Subject: MHI's Responses to US-APWR DCD RAI No. 749-5651 Revision 2 (SRP 19)

Responses to Request for Additional Information
No. 749-5651 Revision 2

RAI NO.: NO. 749-5651 REVISION 2
SRP SECTION: 19 – Probabilistic Risk Assessment and Severe Accident Evaluation
APPLICATION SECTION: SRP Chapter 19
DATE OF RAI ISSUE: 4/28/2011

QUESTION NO.: 19-506

Figure 19-506-1 RCS Pressure History

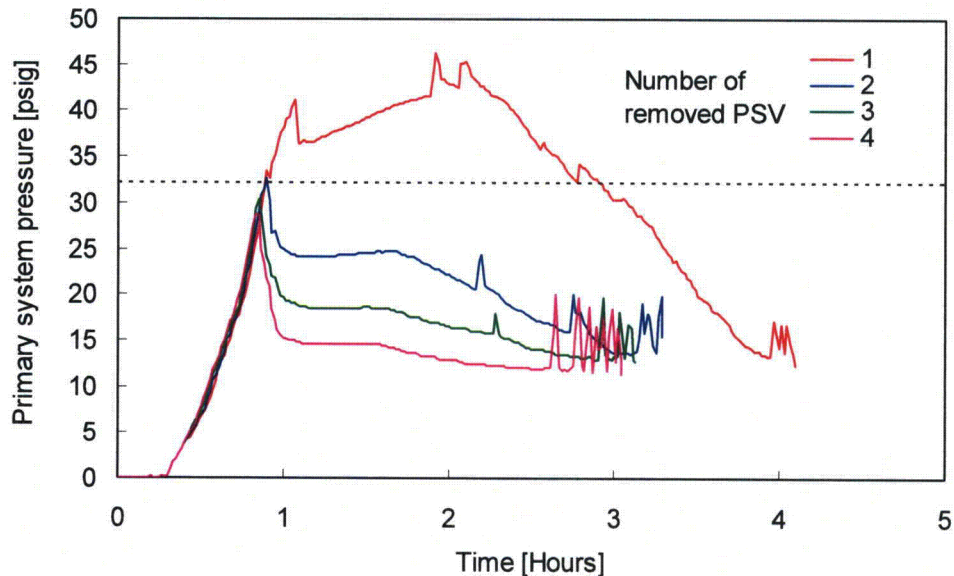
- 1) From the MAAP Analysis described in Table 19-492-1, please clarify if a single pressurizer safety valve was removed.
 - 2) From the MAAP Analysis described in Table 19-492-1, please clarify if the single pressurizer safety valve that was removed was open to containment or connected to the pressurizer relief tank.

- 1) It was assumed that all four pressurizer safety valves were removed for the evaluation performed in the RAI 19-492.

MHI has additionally performed the sensitivity study for the number of removed pressurizer safety valves, and the evaluation result is shown in Figure 19-506-1 below.

It can be observed from this evaluation result that it is necessary to remove at least three pressurizer safety valves to maintain the RCS pressure below the design pressure of SG nozzle dam.

Figure 19-506-2 Location of S/G manhole

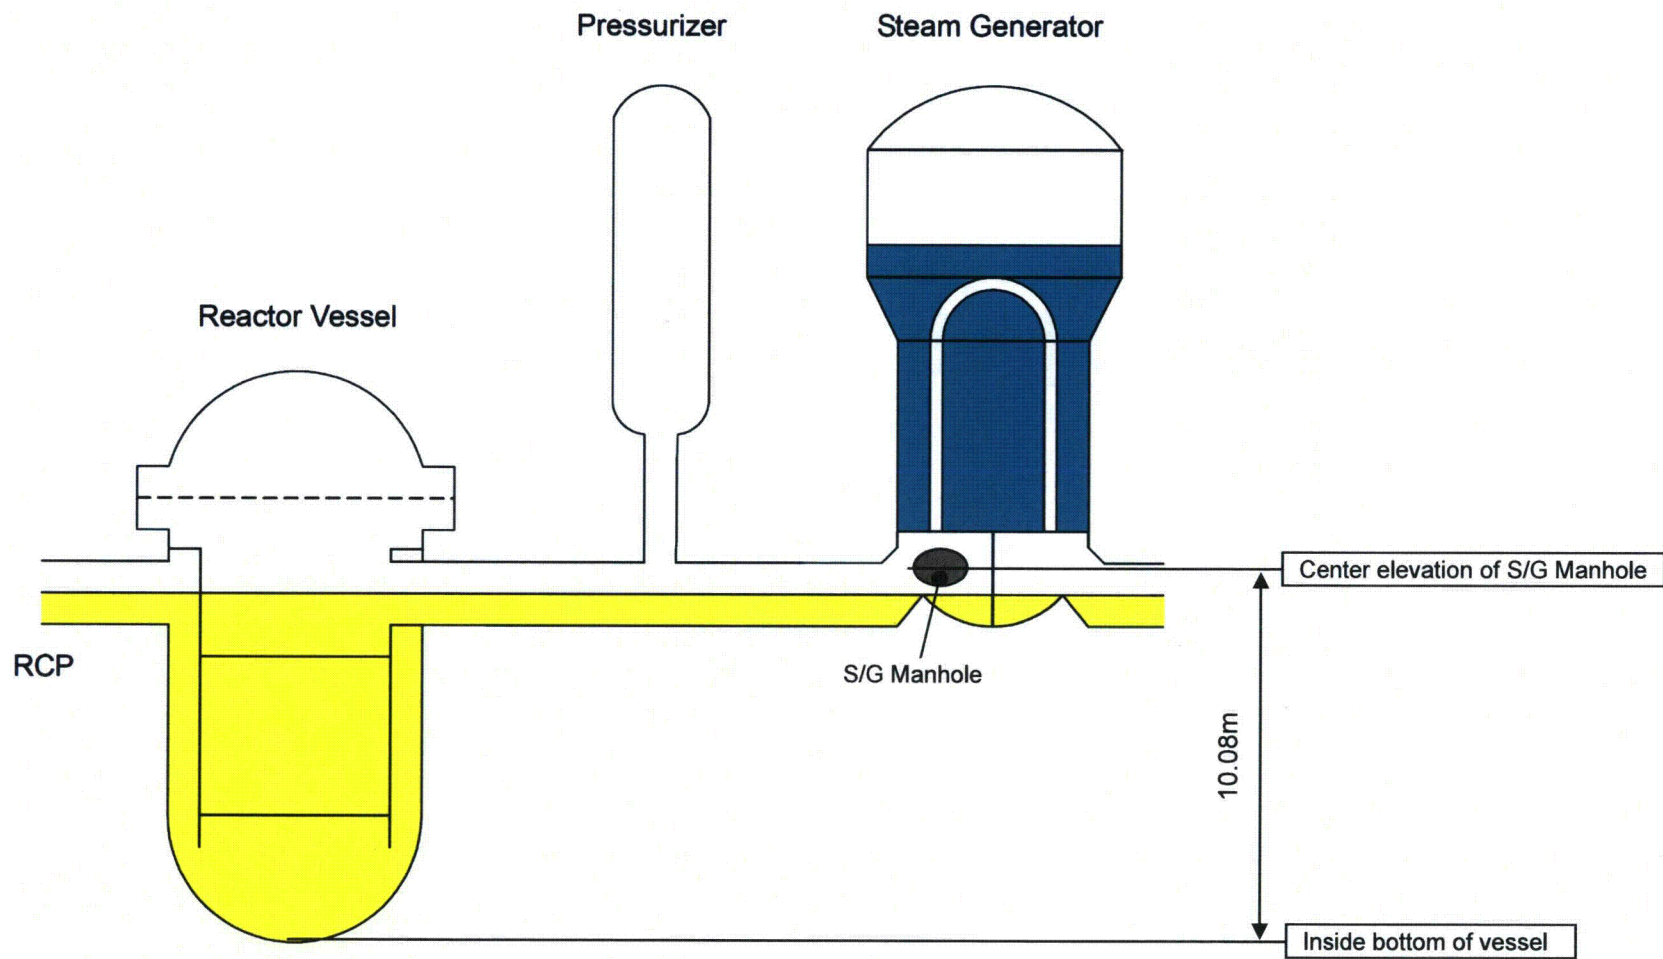
- 4) Regarding the steam generator manways, please provide:
 - a. The base elevation of the manway (lowest elevation) relative to the inside bottom of the vessel.

- b. The top elevation of the manway (highest elevation) relative to the inside bottom of the vessel.
 - c. The flow area and K factor for the steam generator manways used for the MAAP analysis reported in the response to RAI 19-492.
-

- 4) Figure 19-506-2 schematically (not scaled, elevation of MCP and SG connection does not correctly represent the actual design) shows the location of SG manhole. MAAP code input is set as the center elevation of the manhole relative to the inside bottom of the vessel, and

the value is 10.08m. The lowest and highest elevations are calculated by considering the flow area of the manhole.

- a. The lowest elevation of the manhole is 9.85m.
- b. The highest elevation of the manhole is 10.31m.
- c. The flow area for the manhole is 0.164m^2 , and C_d is 0.75.
